DORIS MINE

RESPONSES TO COMMENTS ON MANAGEMENT PLANS, NUNAVUT WATER BOARD:

**Revisions to Amendment Application No. 1 of Project Certificate No. 003 and
Water Licence No. 2AM-DOH1323: Proponent's Response Comments on
Management Plans**

June 2016

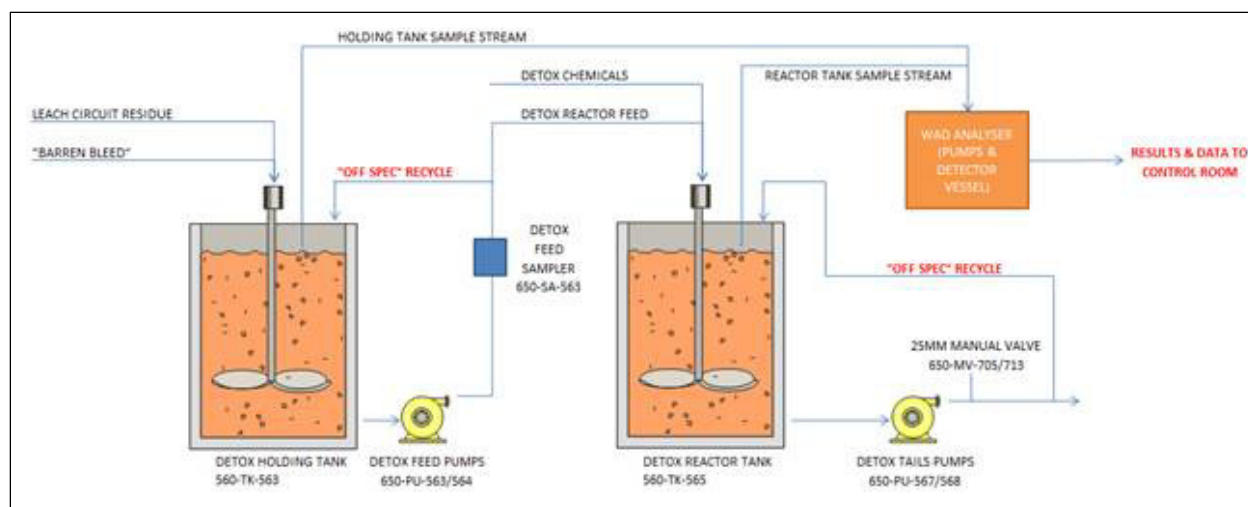
TMAC proposes removing station TL-9 (Barren Bleed Solution sent to tailings taken from a sampling valve with the mill) because the amended project will no longer use this process. During the June 6-8 meetings, TMAC stated there was no analogous process under the revised processing, but that they would look into if there was any liquid along the cyanide process that could be analysed to see how successful the sulphur-dioxide-oxygen cyanide destruction process was.

INAC R33: INAC recommends that station TL-9 be modified to a location where it can serve to monitor the efficacy of the cyanide destruction process.
